SUB-COMMITTEE ON CARRIAGE OF
CARGOES AND CONTAINERS
6th session
Agenda item 8

CCC 6/8/5
4 July 2019
Original: ENGLISH
Pre-session public release:

**Draft updated version of the unified interpretation of paragraphs 6.9.1.1
and 6.9.1.2 of part A-1 of the IGF Code**

Submitted by IACS

Figure 1: Fuel supply from two tank connection spaces and independent fuel supplies all the way from the fuel tank to the consumers, or other means to control pressure and temperature.

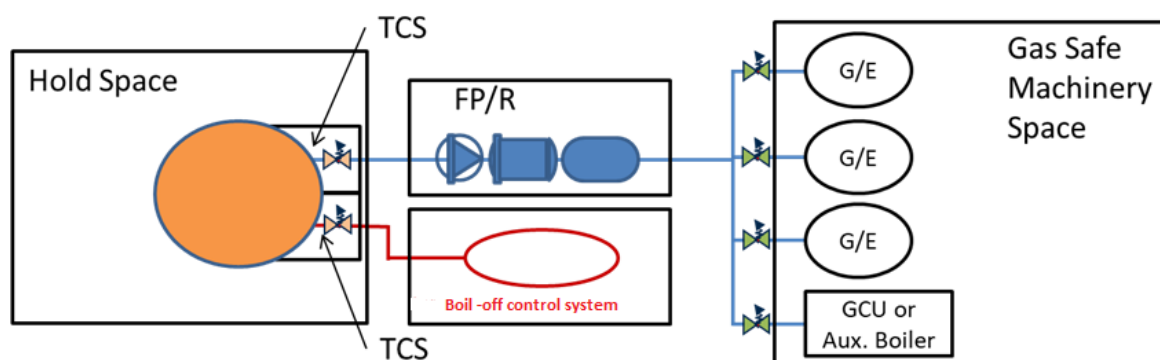
Unless the gas fuel tank is capable of maintaining the tank pressure below the pressure of the tank pressure relief valves for a period of 15 days by pressure accumulation (assuming full tank at normal service pressure and the ship in idle condition) other methods of boil off control in accordance with 6.9.1.1 should be available at all times.

The boil off control should be capable of being maintained after the automatic safety action. This should be achieved by independent fuel supply lines all the way from the fuel tanks to the consumers and more than one means of consuming 100% of the boil off rate, or other equivalent means to control pressure and temperature.

- **Examples of acceptable arrangements are shown in figures 1 and 2:**

Figure 2: Fuel supply from two tank connection spaces and independent fuel supplies all the way from the fuel tank to the consumers.

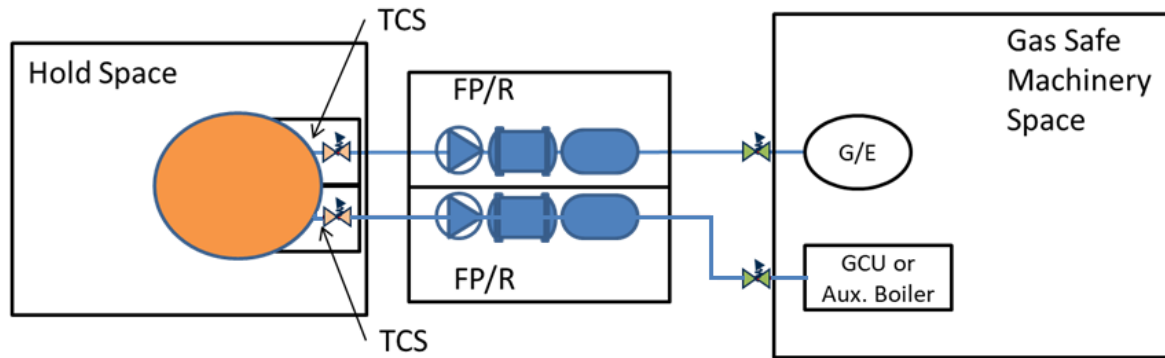
* Each gas consumer is to be provided with "double block and bleed" valves arrangement.
